UNITED STATES PATENT AND TRADEMARK OFFICE

APPLICATION NO.	FILING DATE	FIRST NAMED INVENTOR	ATTORNEY DOCKET NO.	CONFIRMATION NO.
10/055,637	01/23/2002	Stephen L. Siegler	LAWR0021US	9426
24235	7590	03/15/2004	EXAMINER	
LEVINE & MANDELBAUM 444 MADISON AVENUE 35TH FLOOR NEW YORK, NY 10022			FLANDRO, RYAN M	
			ART UNIT	PAPER NUMBER
			3679

Office Action Summary

DETAILED ACTION

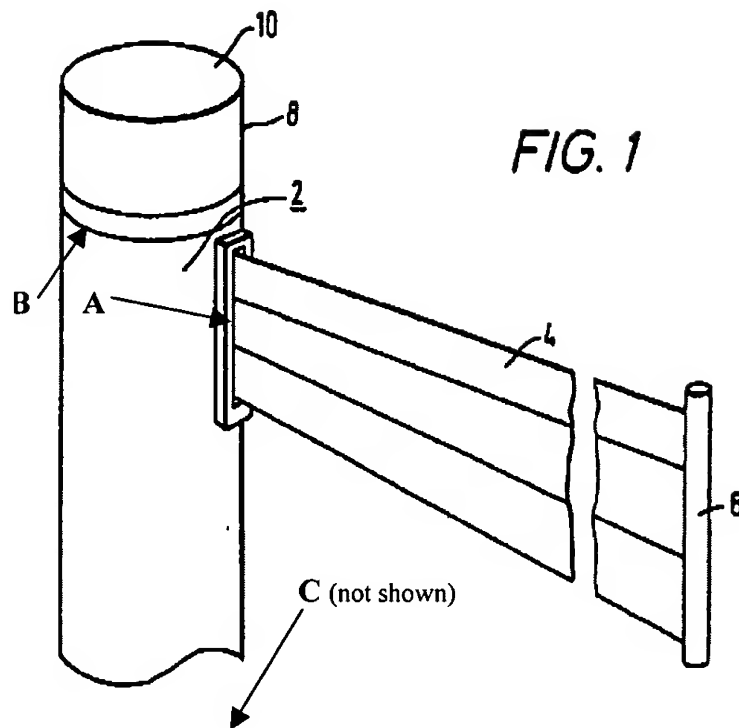
- a. Claim 1. Reading shows and discloses a pedestrian traffic control device comprising a hollow, upright, one piece, post 2 having an open upper end B and a lower end C; at least one slot A in the post 2 between its ends B,C, the slot A

being spaced from both ends B,C of the post 2; a cassette located within the post 2 (see page 7 lines 5-10) and between its ends B,C, the cassette incorporating a tape 4 wound on a spool (see page 7 lines 5-11), the tape 4 being extendable from the cassette (see page 7 lines 10-14), through the slot A in the post 2, in a direction generally perpendicular to the axis of the post 2; the lower edge of the tape 4, when extended, being spaced from the upper end of the post 2 (see annotated figure 1 below), and means (page 7 lines 5-10) for holding the cassette within the post 2 (see annotated figure 1 below). Reading does not explicitly show or disclose the lower edge of the tape 4, when extended, being spaced from the upper end of the post 2 *at least several inches*. It is, however, within the scope of Reading's invention to make the lower edge of the tape 4 spaced at least several inches from the upper end B of the post 2. Depending upon the width of the tape 4 and, in turn, the length of the slot A along the post 2, Reading would meet this limitation. In any event, it has been held that where the general conditions of a claim are disclosed in the prior art, discovering the optimum or workable ranges involves only routine skill in the art. *In re Aller*, 105 USPQ 233 (CCPA 1955). Therefore, it would have been obvious to one having ordinary skill in the art at the time the invention was made to arrange the lower portion of the tape of Reading, when extended, being spaced from the upper end of the post at least several inches since this is within the scope of Reading's disclosure and well within the ordinary skill of one in the art.

b. Claim 2. Reading further shows the post 12 and cassette are both generally circular in cross-section, and the outer diameter of the cassette 22, along its entire axial length, is smaller than the internal diameter of the post 12 (see annotated figure 1 above and figure 2). As to the recitations that the cassette 22 can be inserted into the open upper end of the post 12 and moved to its location between the ends of the post 12, Reading meets these limitations but the method of forming the device is not germane to the issue of patentability of the device itself. Therefore, this limitation has not been given patentable weight.

d. Claim 7. Reading, as applied above, also shows a pedestrian traffic control device, the device 10 including a hollow post 2 having an open upper end B and a

slot A between and spaced from the post 2 ends B,C, the lower edge of the slot A being spaced from the upper end of the post 2 at least several inches, and a cassette incorporating a spool (not shown but see page 7 lines 5-10) on which a tape 4 is completely wound, the free end of the tape 4 being exposed, the method including the steps of inserting the cassette into the open end of the post 2, maneuvering the cassette along the length of the post 2 until the free end of the tape 4 is accessible through the slot A in the post 2; pulling the free end of the tape 4 through the slot A; and attaching a finger pull 6 to the free end of the tape 4 exposed outside the post 2, the pull 6 being sized large enough so that the free end of the tape 4, with pull 6 attached, cannot be retracted into the post 2 through the slot A (see annotated figure 1 above; pages 7-8).

e. Claim 8. Reading lastly discloses that the tape-carrying spool is spring biased (see page 7 lines 8-11) in a direction tending to wind the tape 4 on the spool, so that pulling the free end of the tape 4 through the post slot A adds tension to the spring (see annotated figure 1 above; pages 7-8).
